| 8802-3/802.3 REVISION REQUEST 1148 |

REQUESTED REVISION:
STANDARD: IEEE Std 802.3-2002
CLAUSE NUMBER: Figure 27-1
CLAUSE TITLE: 100BASE-T repeater set

Figure 27-1—100BASE-T repeater set relationship to the ISO/IEC OSI reference model

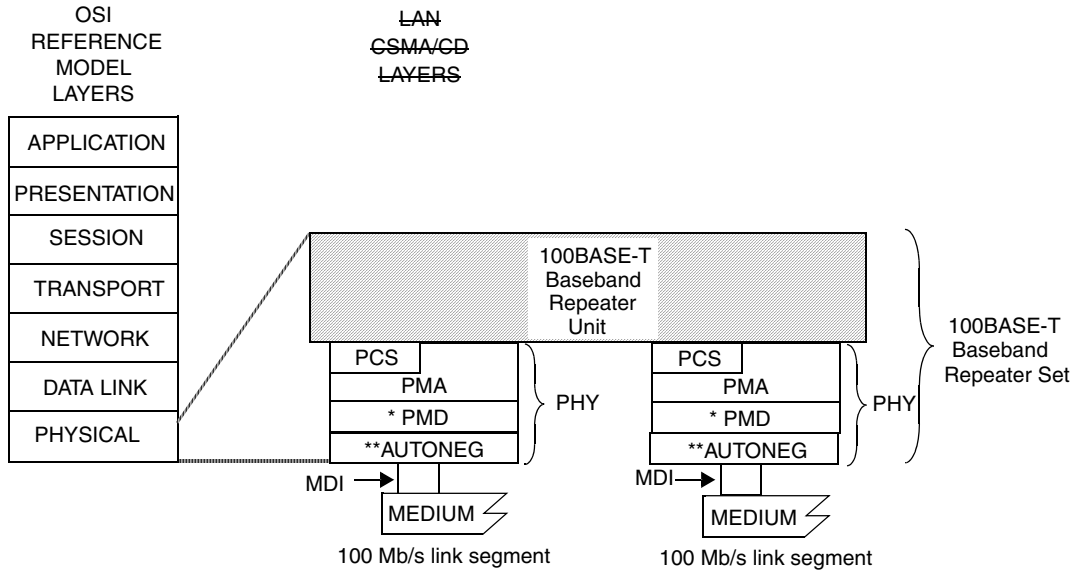
Remove text

LAN
CSMA/CD
LAYERS

Figure has text hanging out in midspace with no attachment to a layer.
Figure in Clause 41 has more detail and text has a reference point.

Change Figure 27-1 as follows:
